City of Portland, Maine - Building or Use Permit Application

Proposed Project Description:
Build New 74,000 sq. Ft. Elementary school.

PROJECT: EAST END SCHOOL
 DRAWING TITLE: REVISED SERVICE AREA & LOADING DOCK

Addendum #1

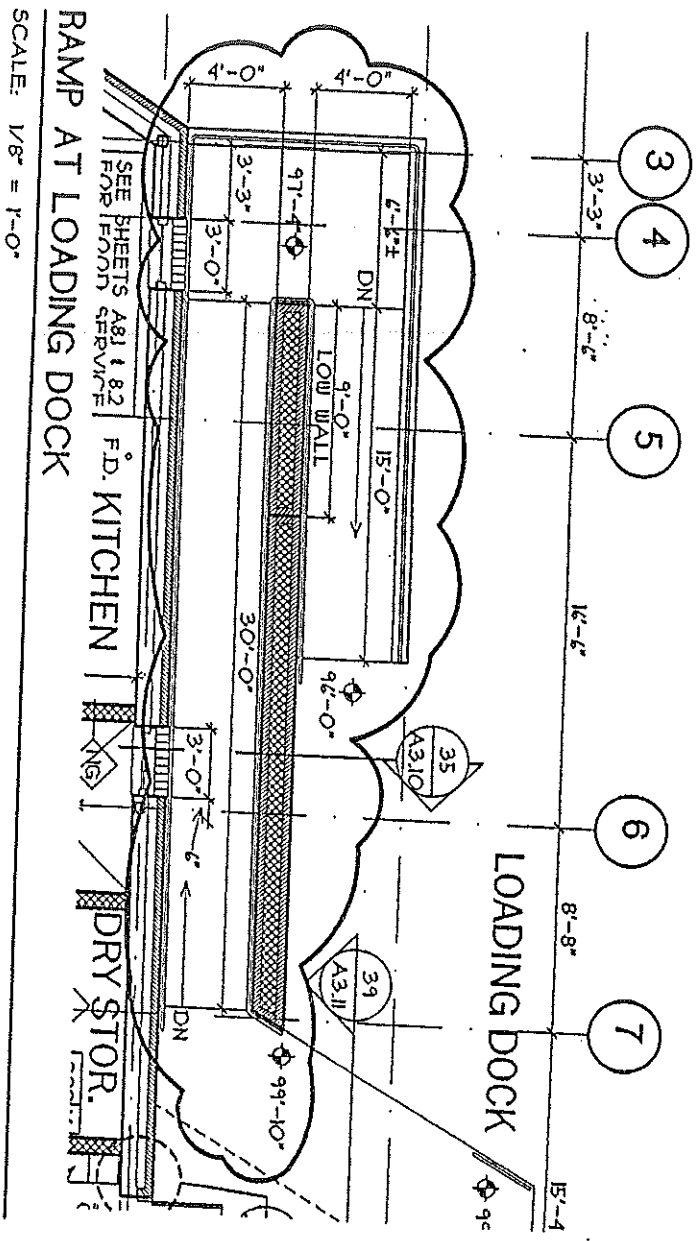
CHANGE: The grades and layout of the ramp to the loading dock on the northwest corner of the building have been revised as shown on SK-C-1, attached.

CHANGE: Loading Dock ramp configuration per attached ASK-1.

ASK-4

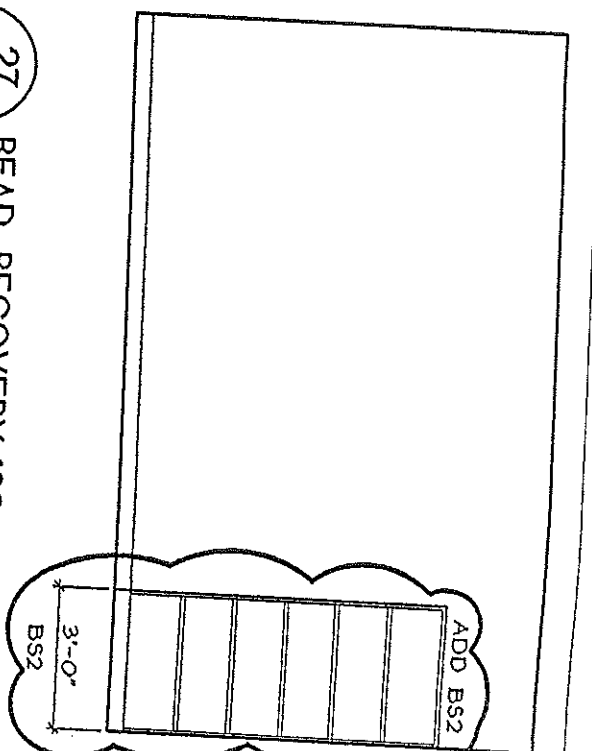
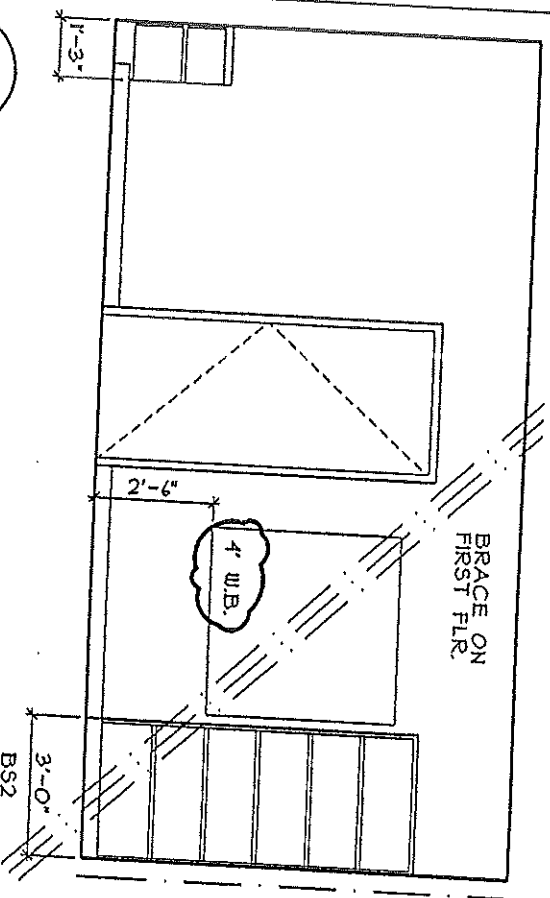
CHANGE: Interior Elevation 1/A1.4 per attached ASK-4.

ASK-5

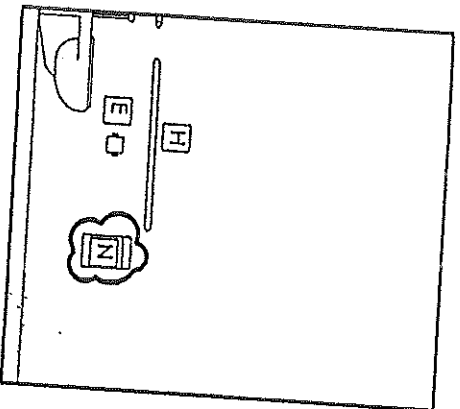
ADD: BS2 and Grip Strip to Room No. 122 Reading Recovery per attached ASK-5.

CHANGE: Width of Whiteboard at Room Nos. 140 & 230 per attached ASK-5.

ADD SANITARY NAPKIN DISPOSAL ROOMS 155, 243, 305, 310, & 203
SCALE: 1/4" = 1'-0"

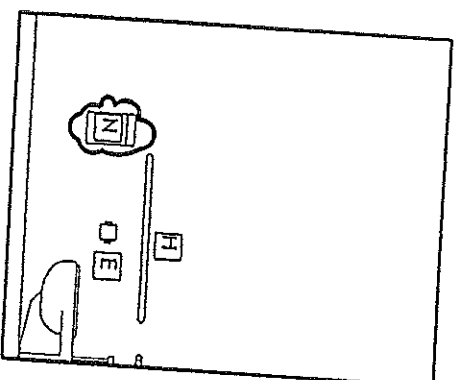
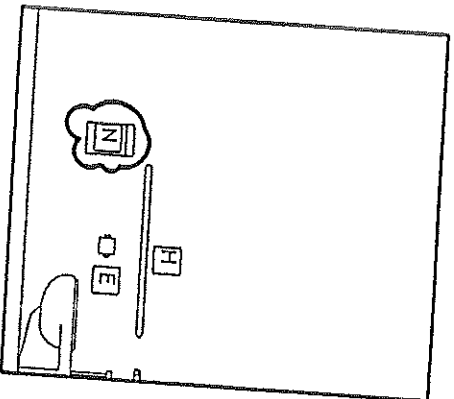
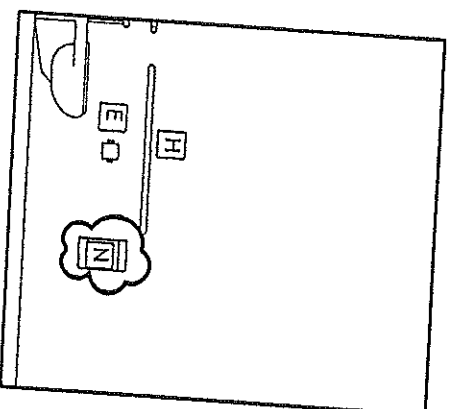
ADD: Sanitary napkin disposal per attached ASK-6.

ADD: Sanitary napkin disposal per attached ASK-6.

ASK-7

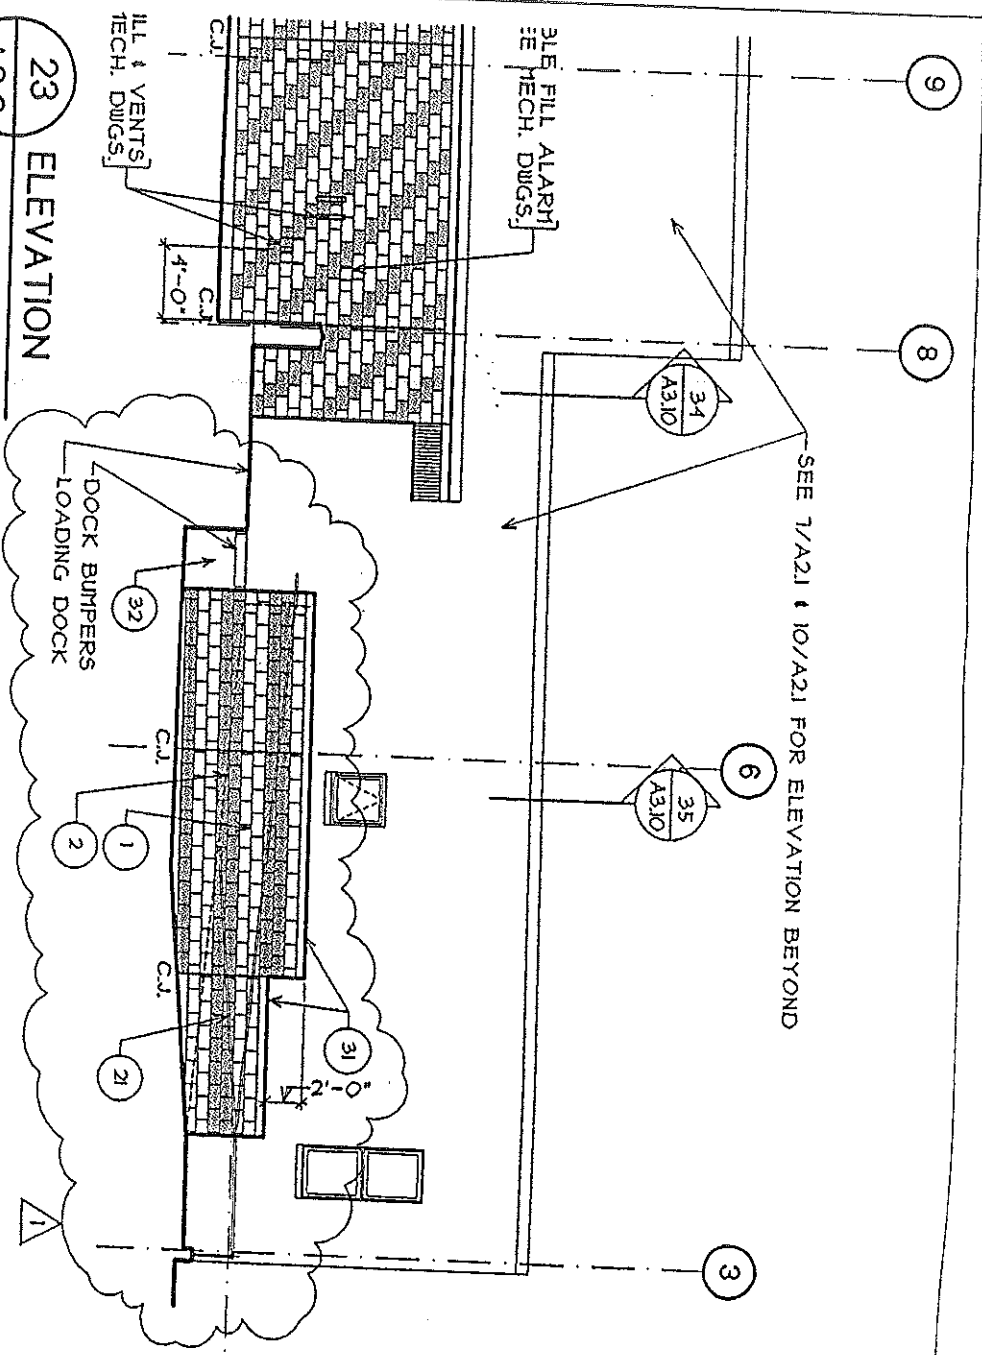
CHANGE: Elevations 7/A/2.1 and 10/A/2.1 per attached ASK-7.

27 ELEVATION
 SCALE: 3/32" = 1'-0"

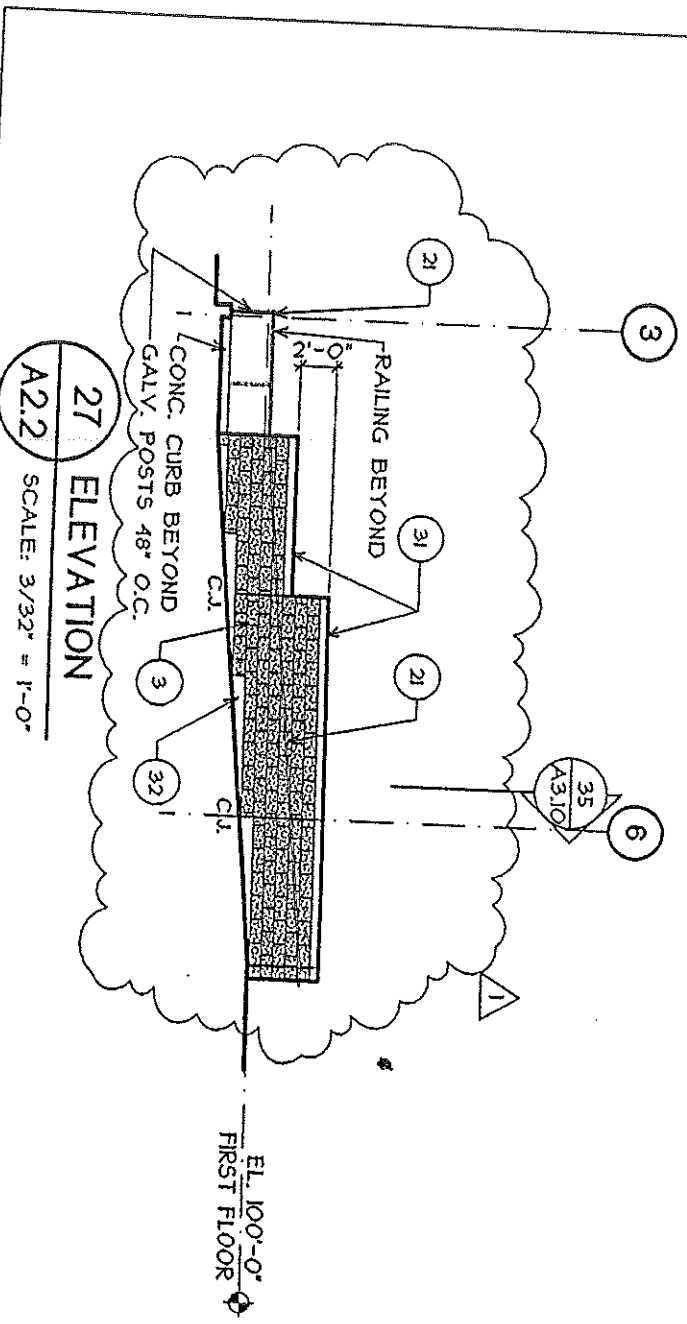
CHANGE: Elevations 23/A/2.2 and 27/A/2.1 per attached ASK-8.
